# Access Compliance Report

## Public Rights-of-Way

### (Curb Ramps)

Intersection ID: 13806	Main Street: S_TRYON_ST	Cross Street: WEST_BV	Location: SE
ADA ID: 7463BEF5A1E2	Ramp Type: Perp	Initial Pass/Fail: Fail	Overall Compliance: No
Severity Score: 13.75			
Codes/Mitigation Info/Possible Solution		Field Measurements/Component Compliance

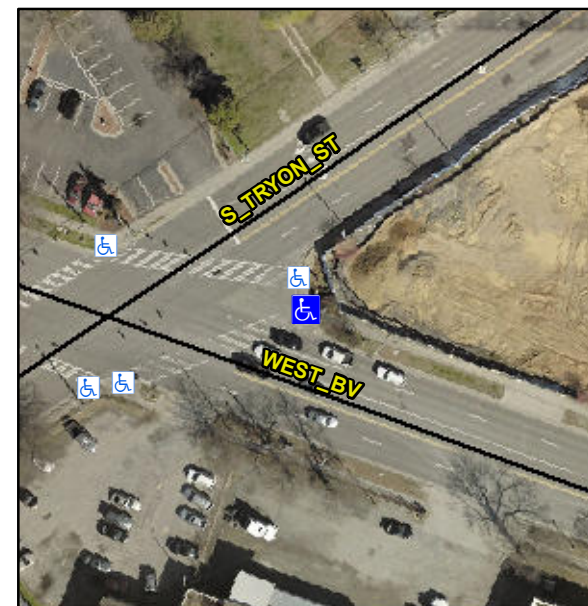
**R304.2.2, R304.5.3**

Compliance	Description	Data	Compliance	Description	Data
N/A	Ramp Length (in)	54.0	No	Ramp Slope (%)	8.4
Yes	Ramp Width (in)	51.0	No	Ramp XSlope (%)	3.0
N/A	Flare Type LT	N/A	N/A	Flare Type RT	N/A
N/A	Flare Slope LT (%)	N/A	N/A	Flare Slope RT (%)	N/A
N/A	Flare Traversable LT?	N/A	N/A	Flare Traversable RT?	N/A
N/A	Landing Length (in)	N/A	N/A	DWS Provided?	N/A
N/A	Landing Width (in)	N/A	N/A	DWS Contrast?	N/A
N/A	Landing Slope (%)	N/A	N/A	DWS Length (in)	N/A
N/A	Landing X Slope (%)	N/A	N/A	DWS Full Width?	N/A
N/A	Landing Curb? (Y/N)	N/A	N/A	DWS Offset (in)	N/A
N/A	Shared Landing?	N/A			
N/A	Gutter Ponding?	N/A	N/A	Gutter Slope (%)	N/A
N/A	Gutter Lip Ht (in)	N/A	N/A	Gutter X Slope (%)	N/A
N/A	Painted X Walk1?	Yes	N/A	Painted X Walk2?	N/A
	X Walk 1 Direction	To SW		X Walk 2 Direction	N/A
N/A	X Walk 1 Width (in)	114.0	N/A	X Walk 2 Width (in)	N/A
	X Walk 1 Slope (%)	2.2		X Walk 2 Slope (%)	N/A
	X Walk 1 X Slope (%)	1.9		X Walk 2 X Slope (%)	N/A

**Remove & Replace Entire Ramp.**
